**ADDENDUM NO. 3**

Date: August 21, 2023

**Project: Project #: 0146-465  
0146-465 Isador Cohen ES / Rosemont HS Security Improvements: Group 1**

**2** TYPICAL ORNAMENTAL VEHICULAR ACCESS GATE NO SCALE

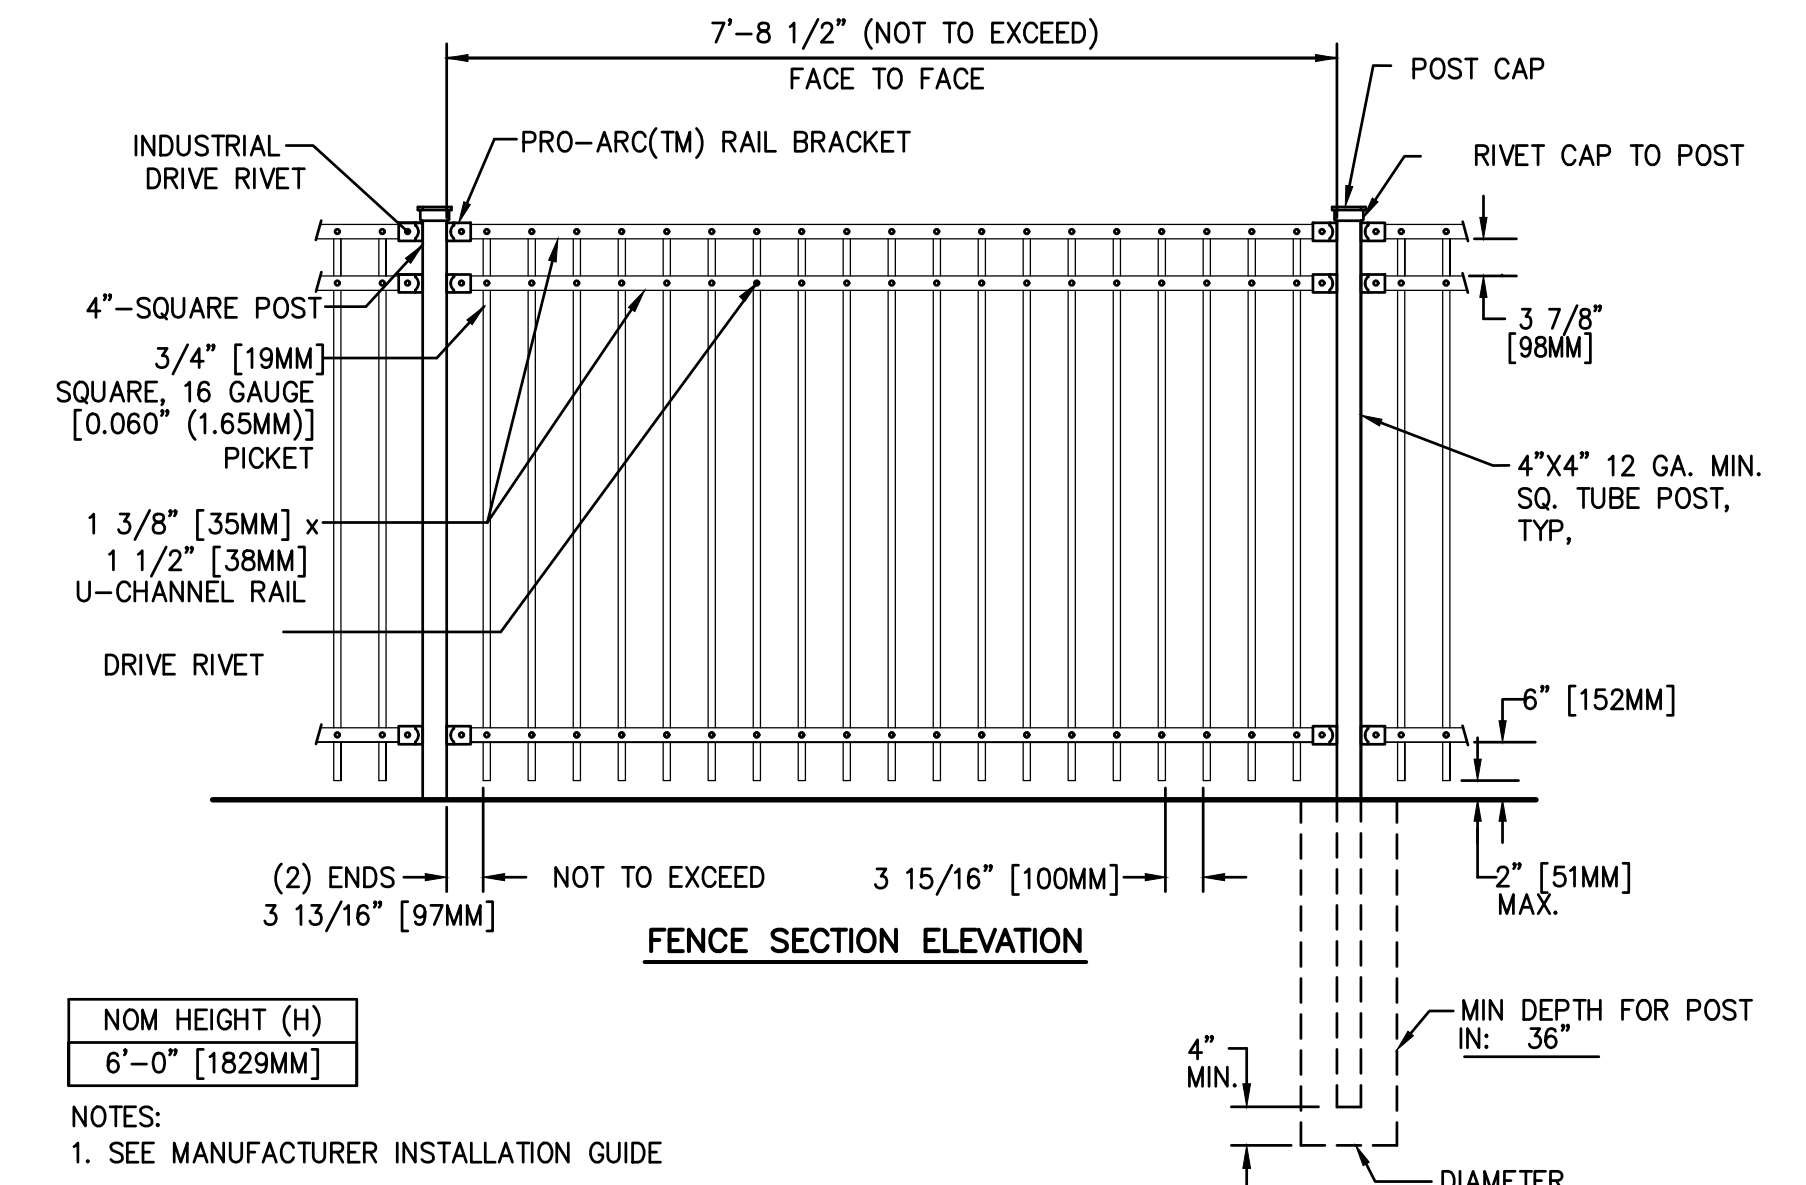
**Sheet C4.2**

- Detail 4 modified and detail 5 and 6 added.

SHEET NO.  
**C4.3**

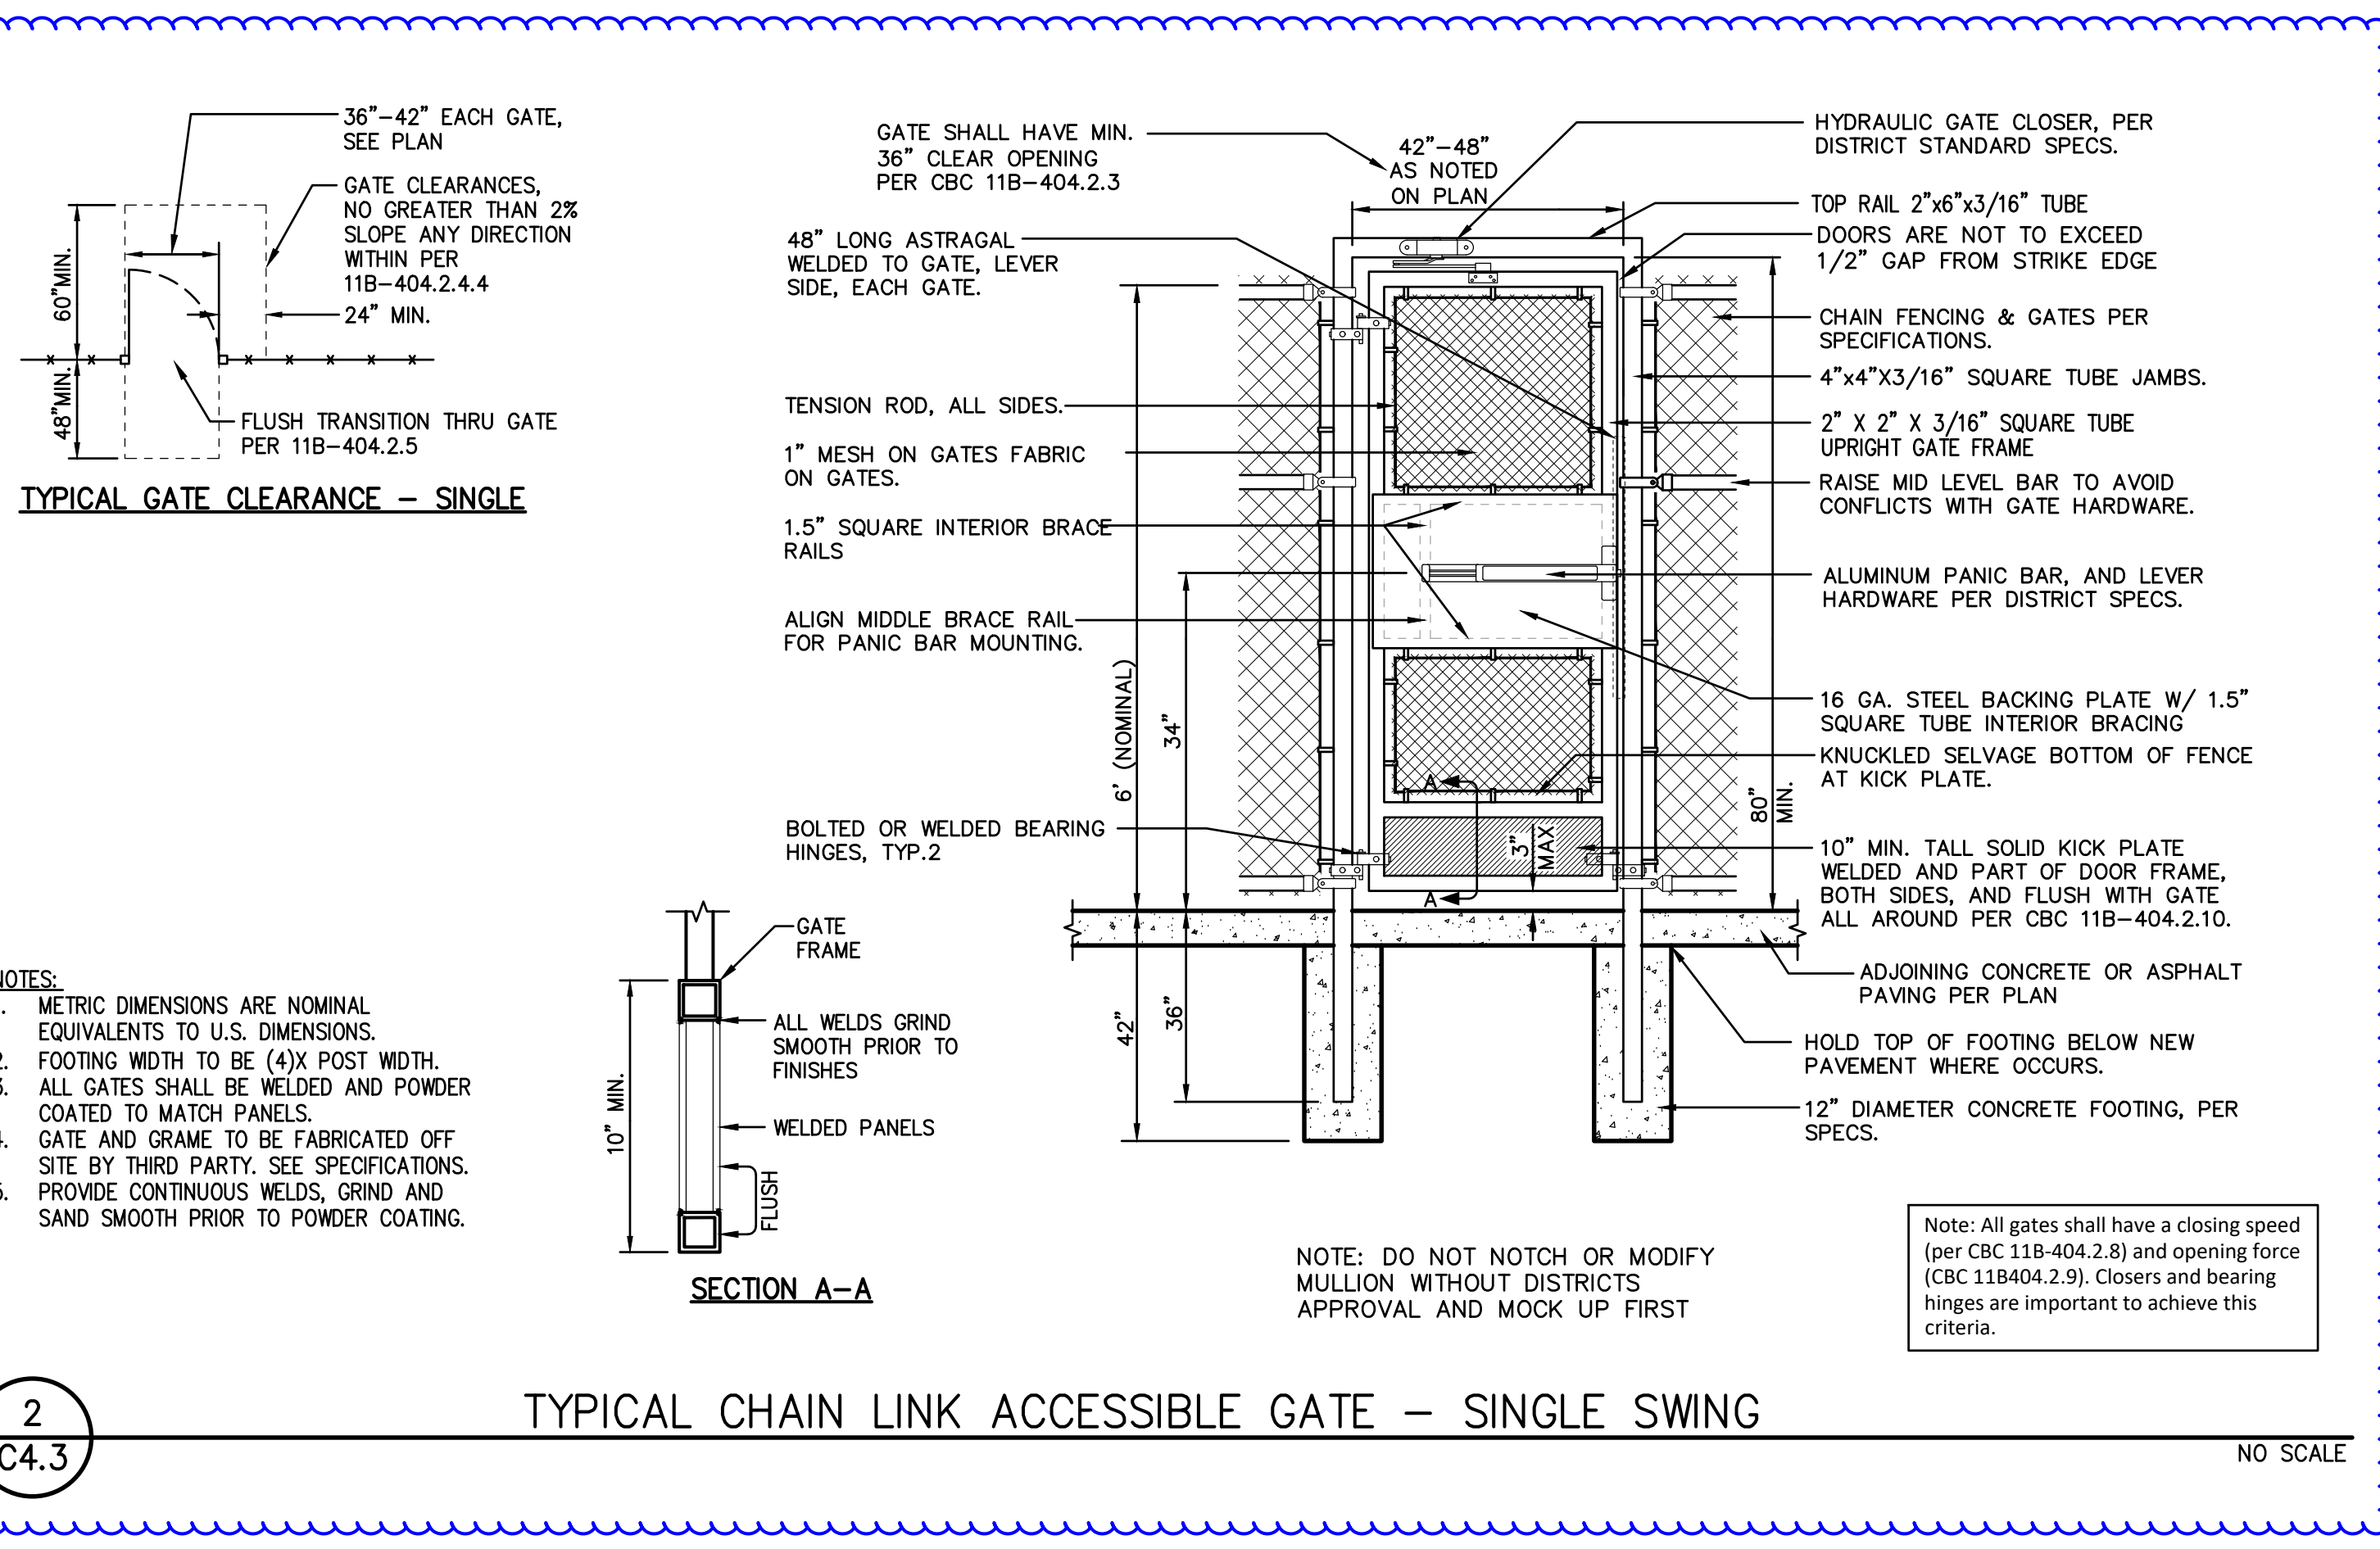
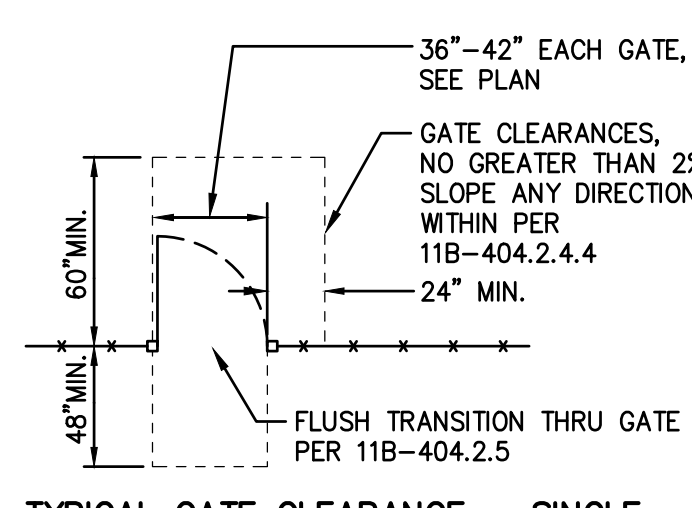
**Sheet C4.3**

- Detail 4 modified and detail 5 and 6 added.
- Details 2 thru 5 eliminated.
- New detail 6 re-numbered to detail 2.
